CONSUMER PRODUCT SAFETY COMMISSION

Safety Standard for Adult Portable Bed Rails

ACTION: Notice of proposed rulemaking; notice of opportunity for oral presentation of comments.

- Section 8.4.5.4. Add the following proposed figures (Figure 4a and Figure 4b) for reference for Zone 3 test:

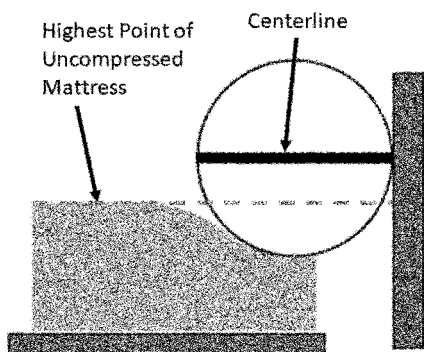
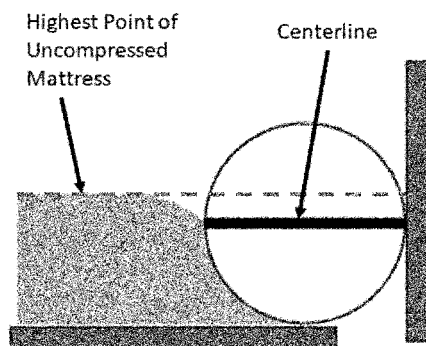
- Section 8.4.5.4: Revise “Turn the cone until the centerline on the face of the 4.7 in (119.38 mm) end is horizontal and let the cone sink into the space by its own weight. (1) If the line on the face of the 4.7 in (120 mm) end of the cone

is above the surface of the mattress highest point of the uncompressed mattress, as shown in Figure 4a, the space passes the test. (2) If the line on the face of the 4.7 in (120 mm) end of the cone is at or below the surface of the mattress, the space fails the test.” Instead of the “below the surface of the mattress” insert “below the highest point of the uncompressed mattress, as shown in Figure 4b.”

Figure 4a: Zone 3 Pass Criteria
(Centerline **above** highest point of uncompressed mattress)

Figure 4b: Zone 3 Fail Criteria
(Centerline **below** highest point of uncompressed mattress)

Figure 1 to paragraph (b)(14) of this section: Zone 3 test: (a) Pass, (b) Fail

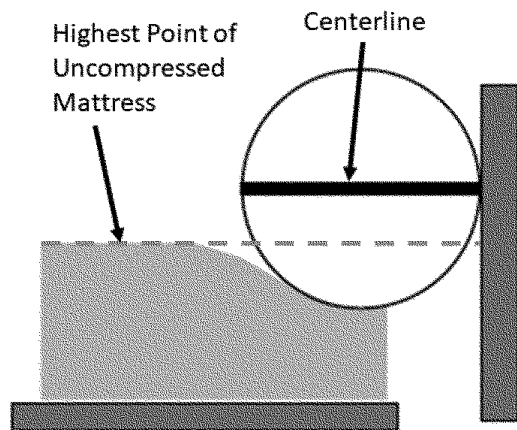
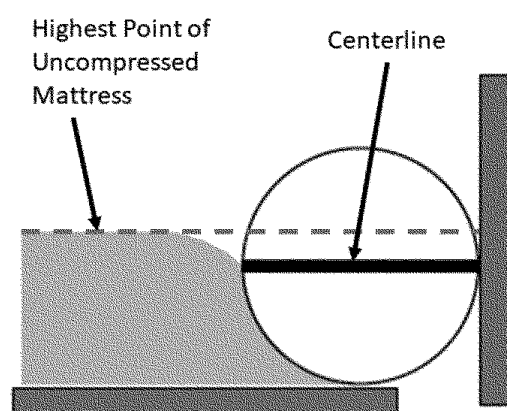
(A) If the line on the face of the 4.7 in (120 mm) end of the cone is above the highest point of the uncompressed mattress, as shown in Figure 1 to paragraph (b)(14) of this section, the space passes the test.

(B) If the line on the face of the 4.7 in (120 mm) end of the cone is at or below the highest point of the uncompressed mattress, as shown in Figure 1 to paragraph (b)(14) of this section, the space fails the test.
